April 25, 2014

RE: River's Peak – Cabernet Builders
Boulder Drive, Barrington – Tax Map 215, Lot 1

We are in receipt of a review letter from DuBois & King dated April 18, 2014, concerning the above referenced project and have addressed the comments below.

Summary for Reach 14R: Swale 6+50 RT to 3+50 RT

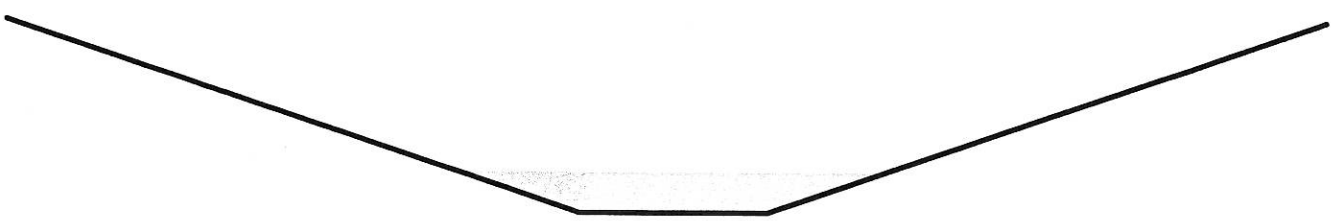
5. **RESPONSE: The swale has been modeled dynamically and the shallower section shows a depth at peak storage of 0.45' under a 50-year event.**
6. **RESPONSE: Pipe materials have been clarified in the gravel wetland detail as requested.**

Peak Storage= 412 cf @ 12.21 hrs
Average Depth at Peak Storage= 0.42'
Bank-Full Depth= 2.00' Flow Area= 16.0 sf, Capacity= 222.39 cfs

Summary for Reach 16R: Swale 29+50 RT to 27+50 RT

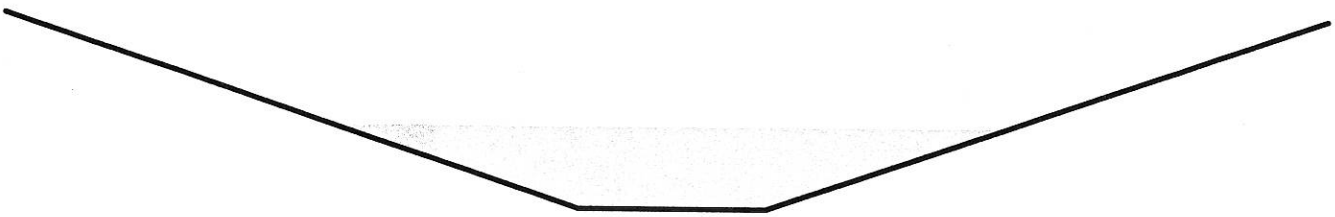
4. **RESPONSE: The worst case scenario (e.g. the interior of the cul-de-sac draining entirely to the road side swale - Subcat #10) has been modeled and as can be reviewed in the attached partial HydroCAD report the 50-year storm event the average depth at peak storage within the 2' deep swale is 0.86'.**

Peak Storage= 783 cf @ 12.27 hrs
Average Depth at Peak Storage= 0.86'
Bank-Full Depth= 2.00' Flow Area= 16.0 sf, Capacity= 118.87 cfs
